Design Review Subcommittee (DRSC)

SUBJECT: **Minor Cultural Heritage Permit (MCHP) 17-300, 102 Ave Victoria Façade Improvements**, a request to consider façade improvements to a multi-tenant, single-story commercial building at 102 Avenida Victoria.

Project: MCHP 17-300 for Facade Improvement

Address: 102 Avenida Victoria

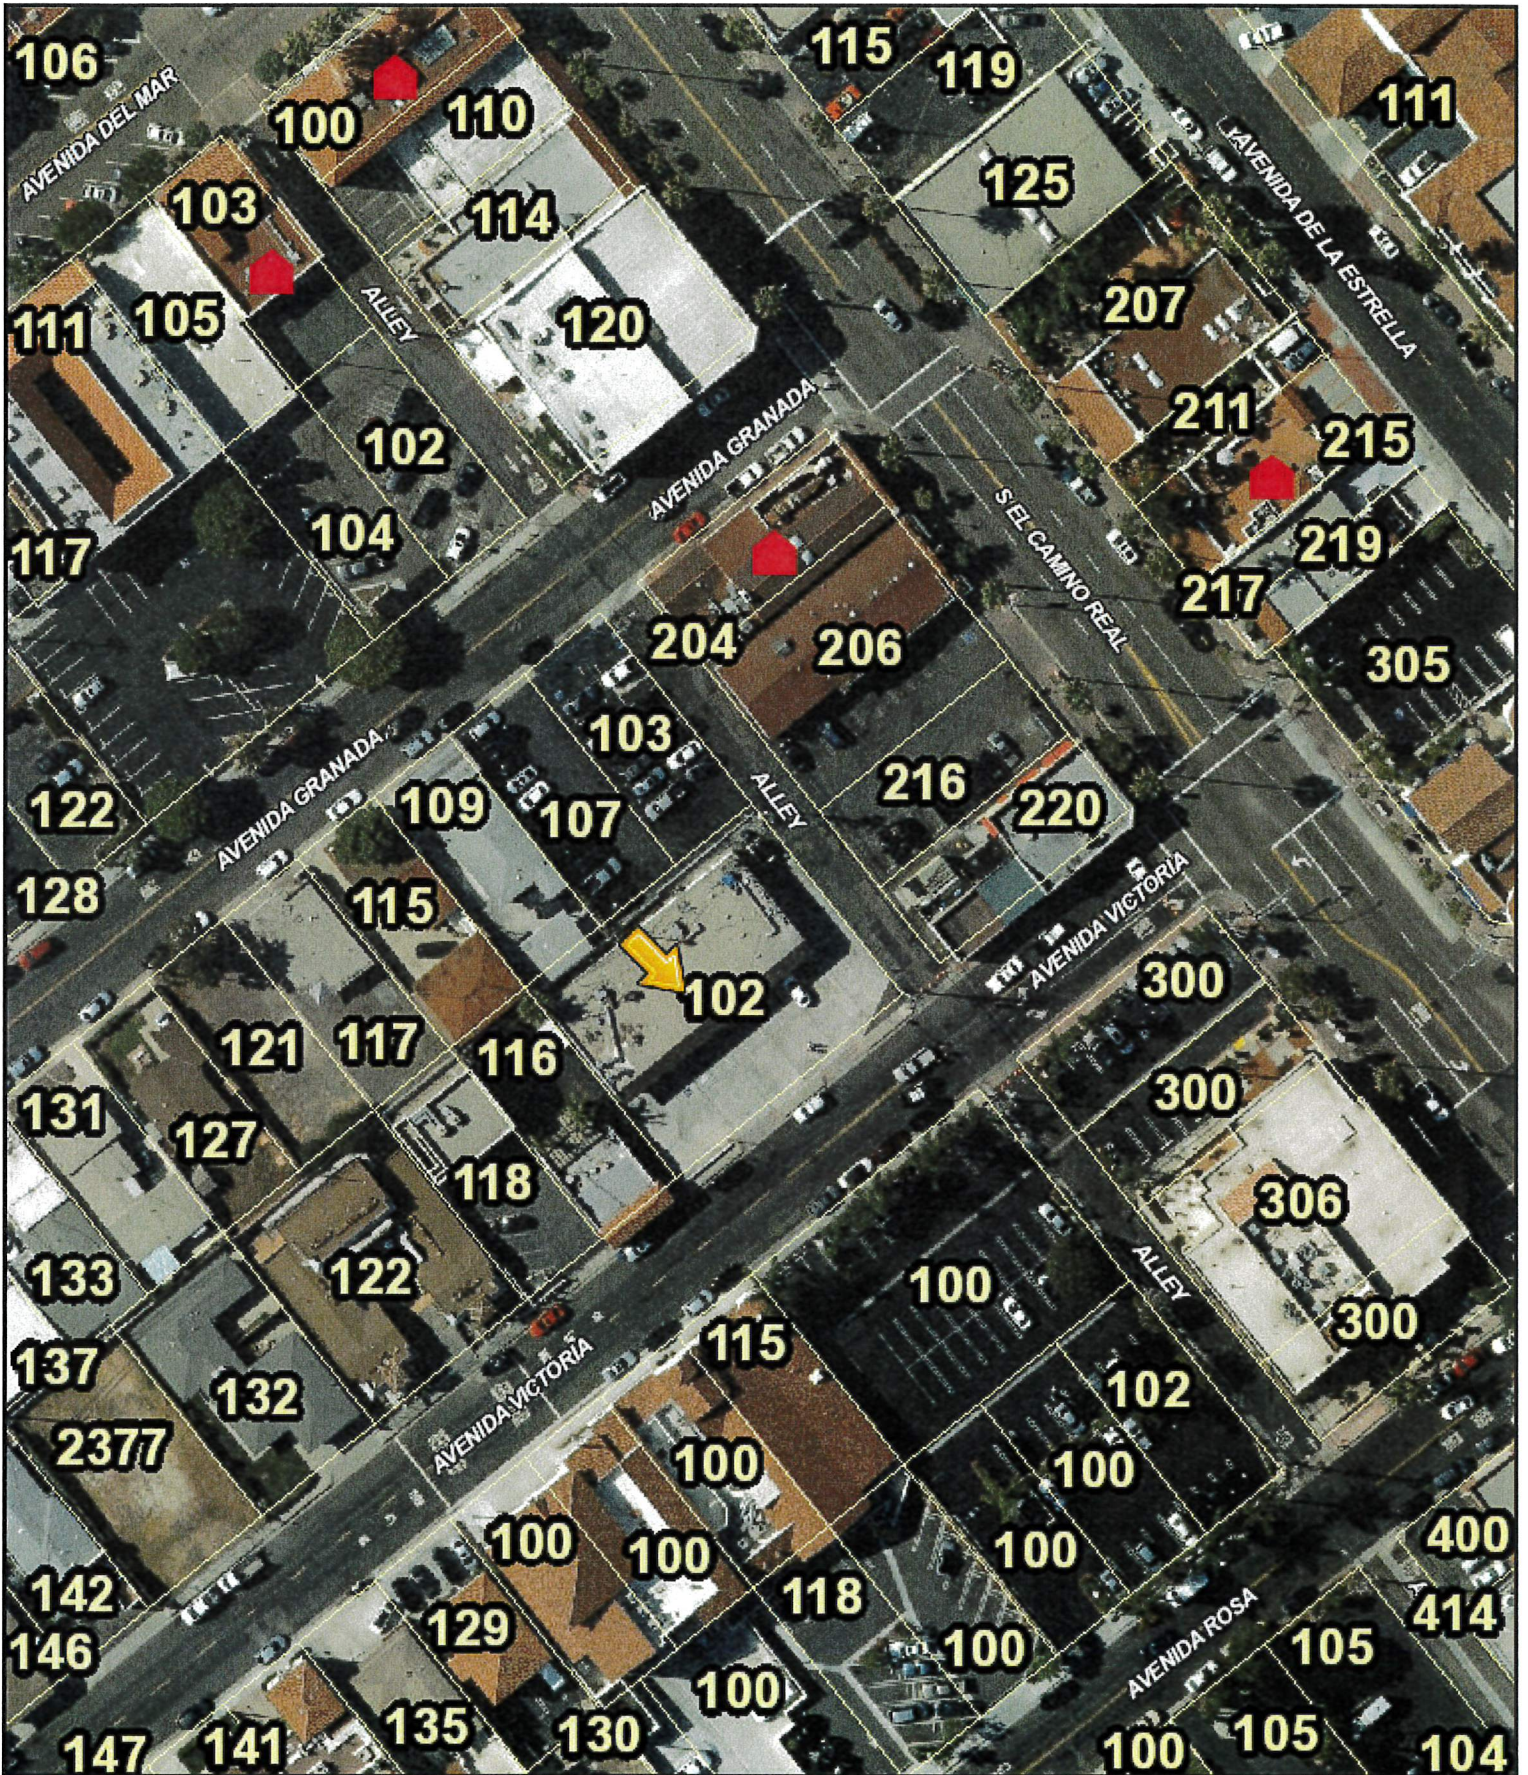
DRSC Recommendation	Applicant Response
1. The applicant should explore options (like changes in parking lot striping) to allow for additional landscaping wherever possible.	Modified. The applicant moved the proposed pedestrian pathway to coincide with the existing van accessible parking space, which has created room for a planter strip on the east side of the lot. This is in addition to the already proposed 2 foot planter strip on the southwest edge of the parking lot and the vine pockets on the northeast side of the building. ¹

2. Increasing the massing at the existing posts would help add depth and move closer to SCR style.	Modified as requested.
3. Arches are recommended in the towers, but will not be required.	Not modified. The applicant prefers not to use arches due to a preference by the owner/tenants to maintain existing interior layouts of the stores. The applicant does not want to center the doors in the towers so as to avoid the need for tenants to rearrange their interior spaces.

4. The awnings should be split for visual breaks in the façade.	Modified as requested.
5. The width/scale of the eyebrow canopy should be reduced.	Modified. The applicant removed the eyebrow canopies in favor of using the same awnings proposed for the rest of the frontage.

6. The staff recommendation for stamped concrete could cause drainage/ engineering issues if there is a material change encroaching into the alley.	Modified. The location that staff had recommended for the improved pavement is now going to be a planter strip in the new proposal.

7. Control joints should be removed (or hidden from view).	Modified as requested.

Figure 1 – Proposed NE Corner Elevation of 102 Ave. Victoria

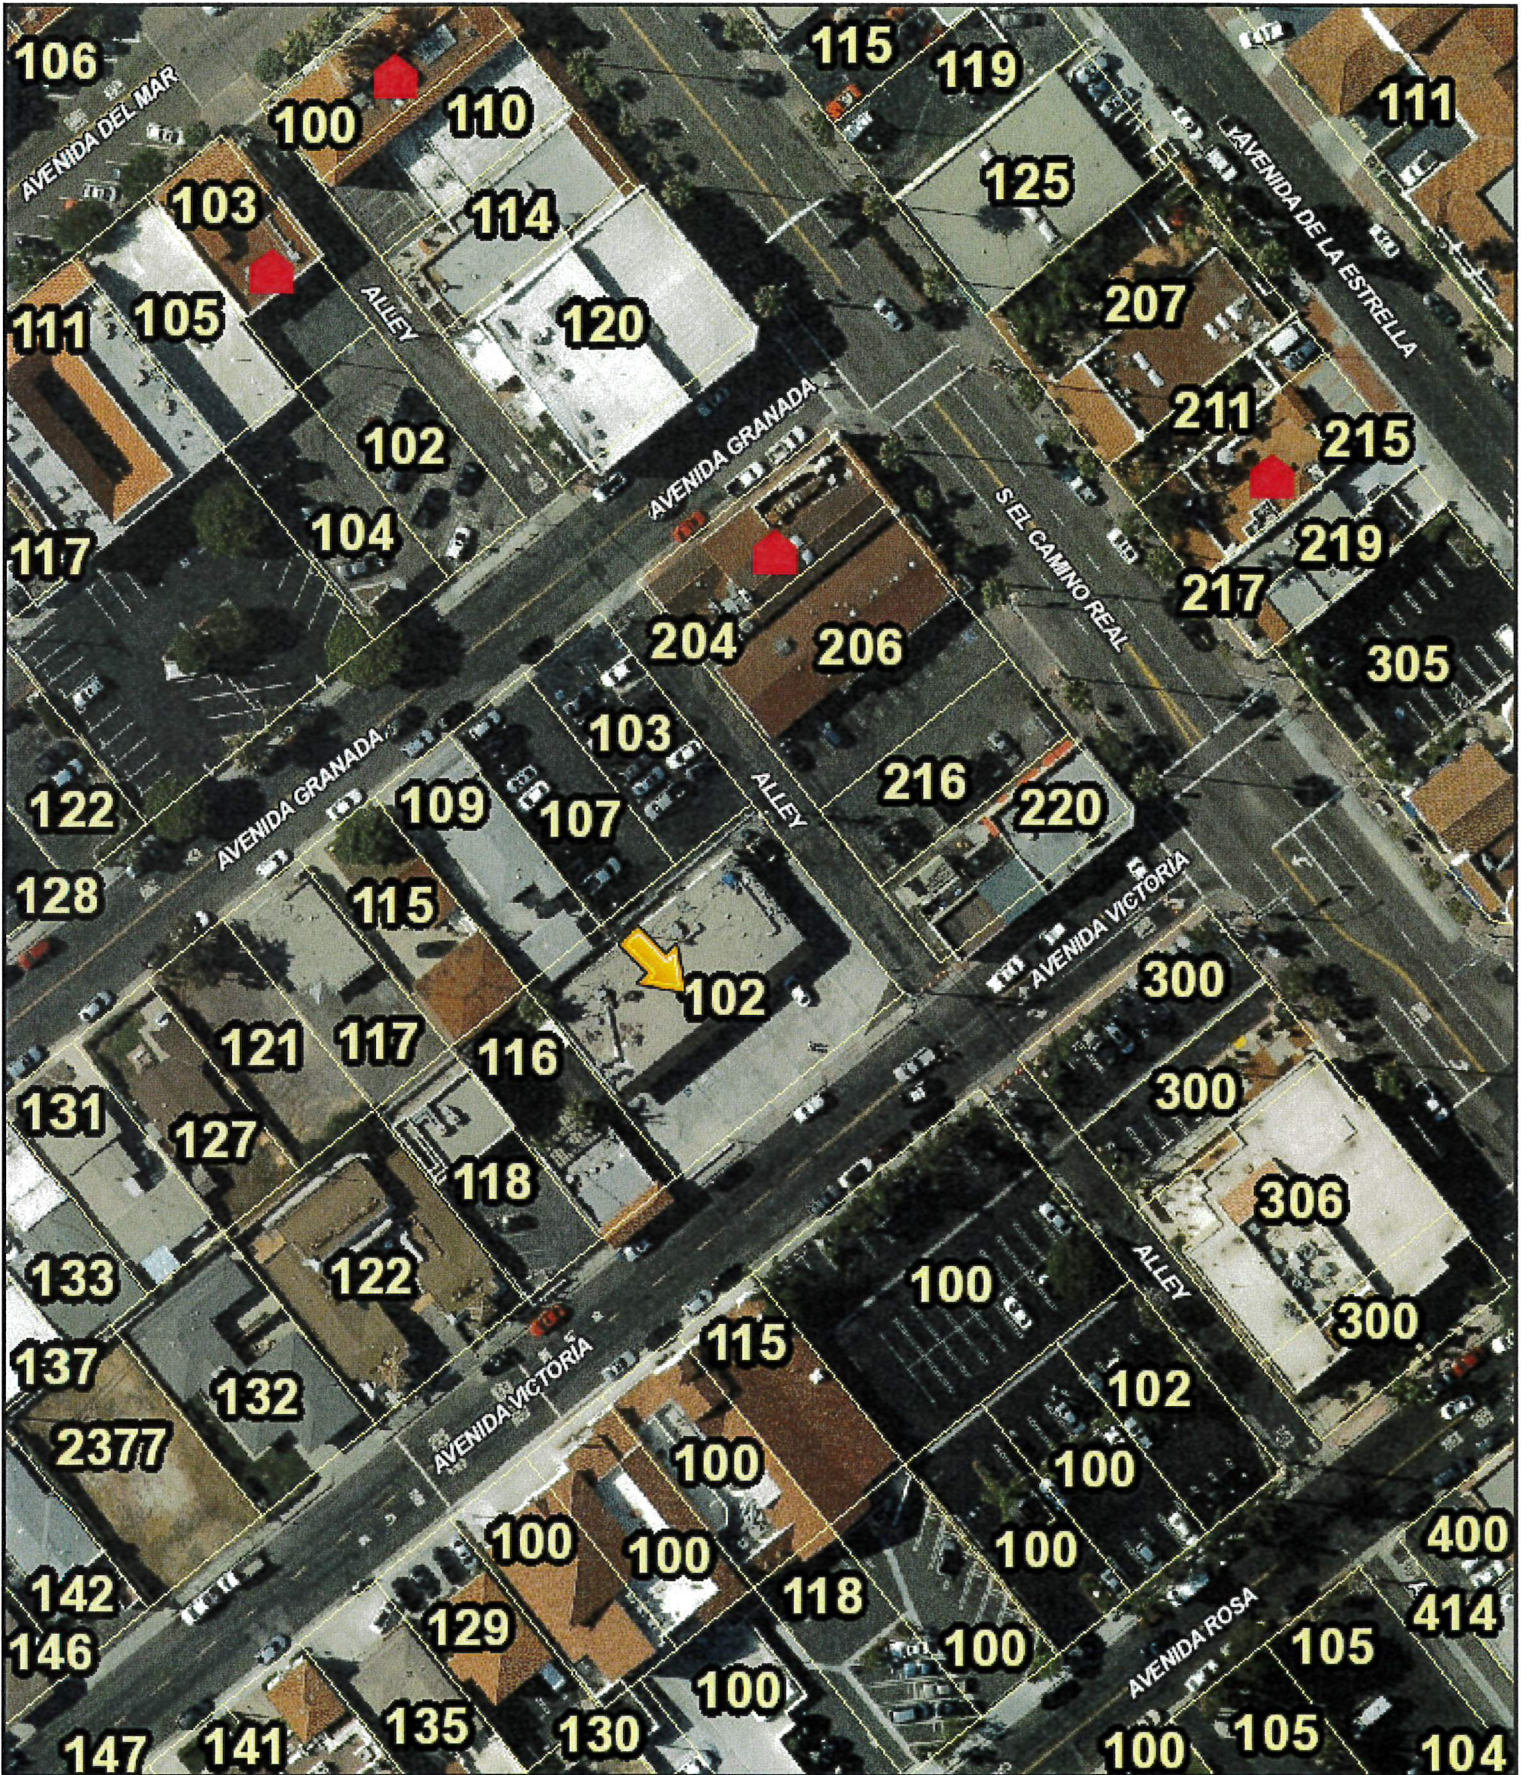
1. Apply a smooth white plaster finish with bull nosed edges to both the front and alley side elevations for material consistency from the public right of way.

2. Add additional wall/plaster massing to “support” the building around the two existing posts that are offset of the central part of the front elevation. Consider adding additional massing to the tower elements by incorporating archways instead of square openings.

3. Steel doors and aluminum windows are acceptable provided their finish and detailing is consistent with a wood door/window. They should have traditional recessed profiles (standard is 8” for windows and 12” for doors), and the aluminum windows should have lites. Additional design emphasis can be added with Catalina style ceramic tile. In particular, staff recommends that Catalina style tile be utilized around the door frame of the tower element instead of as a decorative accent in a frame.

4. The cornice should be thickened and painted white to match plaster.
5. Remove the quatrefoil, eyebrow canopy, and the recessed lines in the plaster siding.

6. Use the fabric awnings to divide the unbroken mass of the central wall plane. Separate the large awning into several distinct awnings. (Or remove awnings as the front/east elevation does not receive primary sun exposure.)
